Technical Service Bulletin

Topic	Oil leaking from tell tale hole - CDA actuator fixings or Fuel rail fixings or Vaccum assembly fixings - V8 Kovomo
Market area	Australia E04 Bentley rest Asia and Australia (6E04),China 723 Volkswagen (Anhui) Automotive CO (6723),China 796 VW Import Comp. Ltd (Vico), Beijing (6796),Germany E02 Bentley rest Europe (6E02),Japan E03 Bentley Japan (6E03),Korea, (South) E08 Bentley South Korea (6E08),Russian Federation 935 Volkswagen Group RUS (6935),United Arab Emirates E06 Bentley Middle East and Africa (6E06),United Kingdom E01 Bentley UK (6E01),United States E05 Bentley USA and rest America (6E05)
Brand	Bentley
Transaction No.	2064679/5
Level	EH
Status	Released for publishing
Release date	Mar 4, 2025

Figure 1

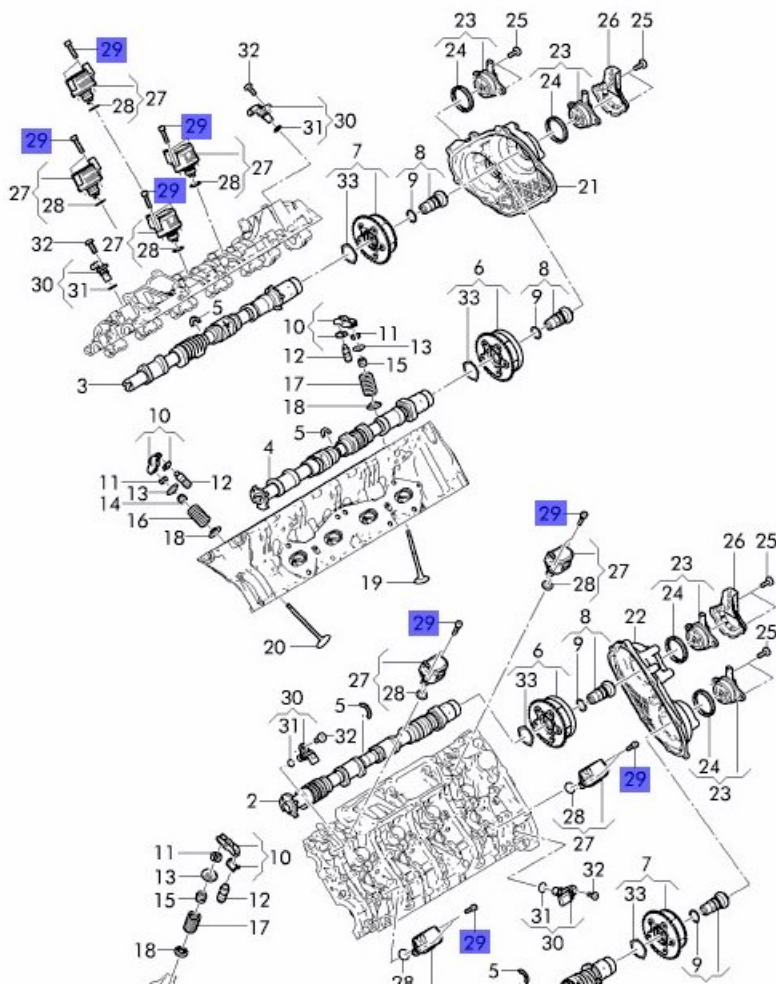
- CDA activation/ deactivation solenoid fixings - Figure 1 (Item 29 - Quantity of 16 in total)

- In the event that x1 (or more) of the CDA solenoid fixing/s are leaking – **All 16 CDA solenoid fixings MUST BE REPLACED as a complete set** - Refer to Rep.Gr 15 - Ensuring the procedure is followed to enable access to all CDA solenoid fixings

Figure 2

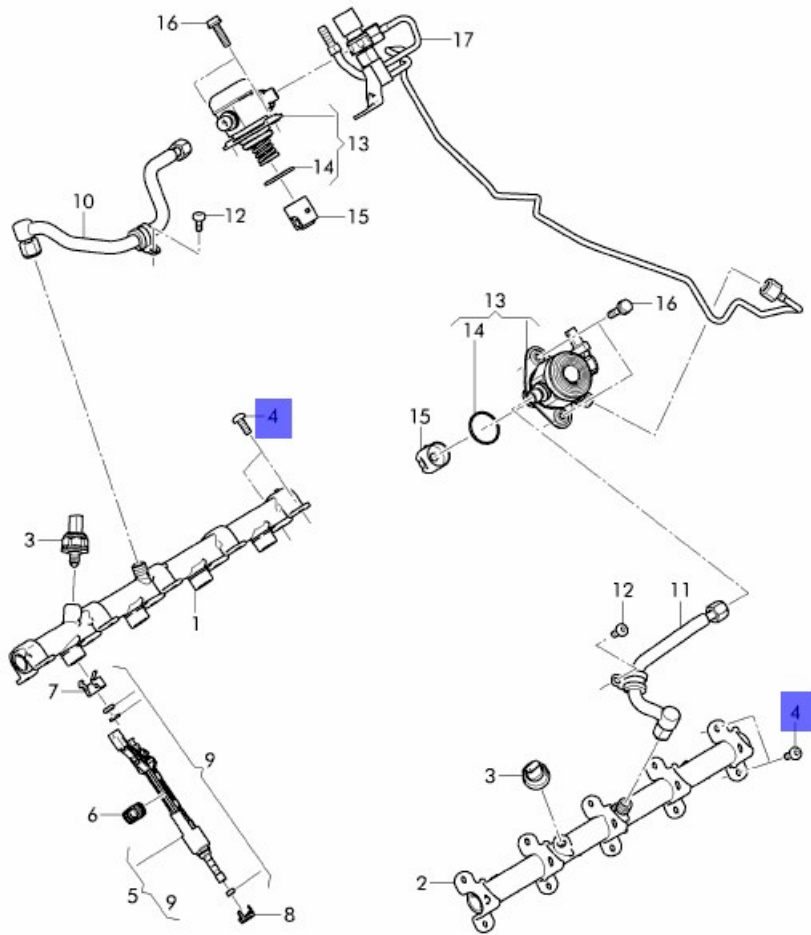
- Fuel rail fixings - Figure 2 (Item 4 - Quantity of 20 in total)

- Refer to Rep.Gr 24 - Fuel rails to remove and refit - Ensure the procedure is followed to enable access to the fuel rail fixings on both Banks 1 and 2 - Replace all 20 fixings

Figure 3

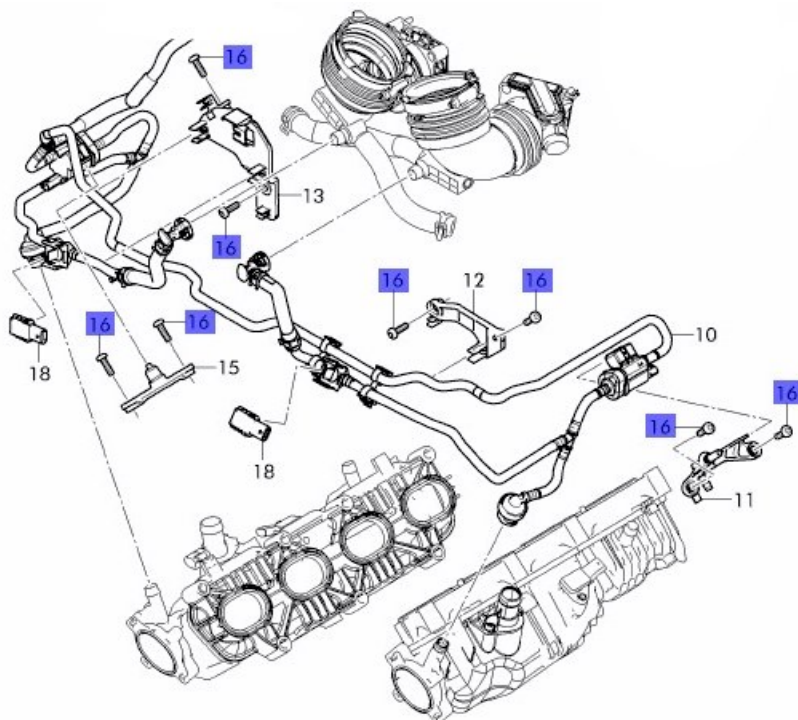
- Fixings for the vacuum system assembly - Figure 3 (Item 16 – Quantity of 8 in total)

TPI 204679/3 - Instruction to replace all 8 vacuum assembly fixings when conducting Scenario 3

- Remove the front end module - Refer to "Front end module - to remove and fit"
- **All models continued**
- Rep.Gr 20 - Evaporative Emission Purge Valve and Rep.Gr 28 - Ignition coil replacement to gain access to the fixings
- Replace all Vacuum assembly fixings
- Refit all previously removed parts

Figure 4

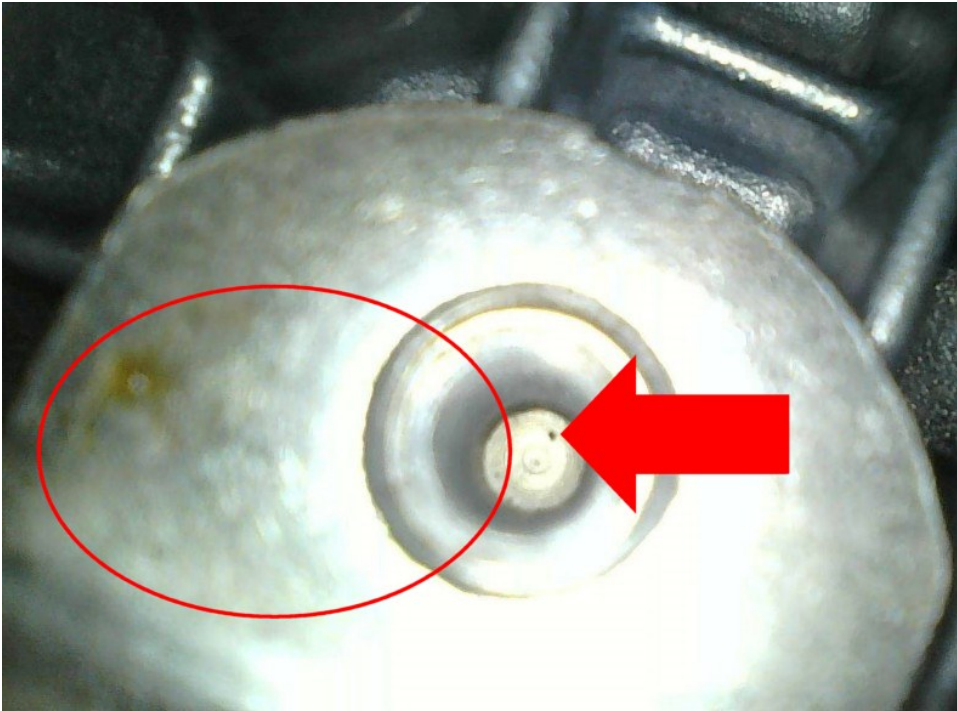
Figure 4 shows oil leaked which had leaked from the tell tale hole at the top of the fixing (Arrow)

Upgraded fixings prevent oil leaks from the tell hole
